## **Access Compliance Report Public Rights-of-Way** (Curb Ramps)

Intersection ID: 20942 Main Street: CORONATION BV **Cross Street: CROWN CENTRE DR** Location: NE ADA ID: 373640690141 Ramp Type: PerpDiag Initial Pass/Fail: Fail **Overall Compliance: No Severity Score:** 25

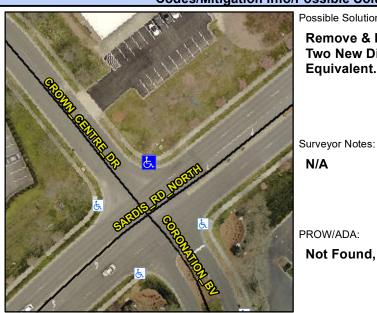
Not Found, R304.2.2, R304.5.3

Compliance Description Data		Comp	iance Desc	ription	Data	
N/A	Ramp Length (in)	68.0	No	Ramp Slope	∈ (%)	8.4
Yes	Ramp Width (in)	48.0	No	Ramp XSIo	pe (%)	6.4
N/A	Flare Type LT	N/A	N/A	Flare Type RT		N/A
N/A	Flare Slope LT (%)	N/A	N/A	Flare Slope RT (%)		N/A
N/A	Flare Traversable LT?	N/A	N/A	Flare Traversable RT?		N/A
N/A	Landing Length (in)	N/A	N/A	DWS Provid	ded?	N/A
N/A	Landing Width (in)	N/A	N/A	DWS Contr	ast?	N/A
N/A	Landing Slope (%)	N/A	N/A	DWS Lengt	h (in)	N/A
N/A	Landing X Slope (%)	N/A	N/A	DWS Full V	/idth?	N/A
N/A	Landing Curb? (Y/N)	N/A	N/A	DWS Offset	t (in)	N/A
N/A	Shared Landing?	N/A				
N/A	Gutter Ponding?	N/A	N/A	Gutter Slop	e (%)	N/A
N/A	Gutter Lip Ht (in)	N/A	N/A	Gutter X Slo	ope (%)	N/A
N/A	Painted X Walk1?	No	N/A	Painted X V	Valk2?	No
	X Walk 1 Direction	To SW		X Walk 2 Di	rection	To SE
N/A	X Walk 1 Width (in)	N/A	N/A	X Walk 2 W	idth (in)	N/A
	X Walk 1 Slope (%)	6.4		X Walk 2 SI	ope (%)	1.7

X Walk 1 X Slope (%)	5.7		X Walk 2 X	Slope (%)	5.4
N/A	Ramp inside XWalk1?	N/A	N/A	Ramp insid	e XWalk2?	N/A
	Road Slope (%)	3.3	N/A	Clear Space	e?	N/A
	Road X Slope (%)	4.8	N/A	Clear Space	e to XWalk (in)	N/A
N/A	Any Obstructions?	N/A	N/A	Storm Grate	e/Utility Hazard?	N/A
	Obstruction Type		l	Storm Grate	e/Utility Type	
		N/A				N/A
			Yes	Surface Co	ndition? (G/P)	Good

Possible Solutions: Remove & Replace Curb Ramp With Two New Directional Ramps or Equivalent.
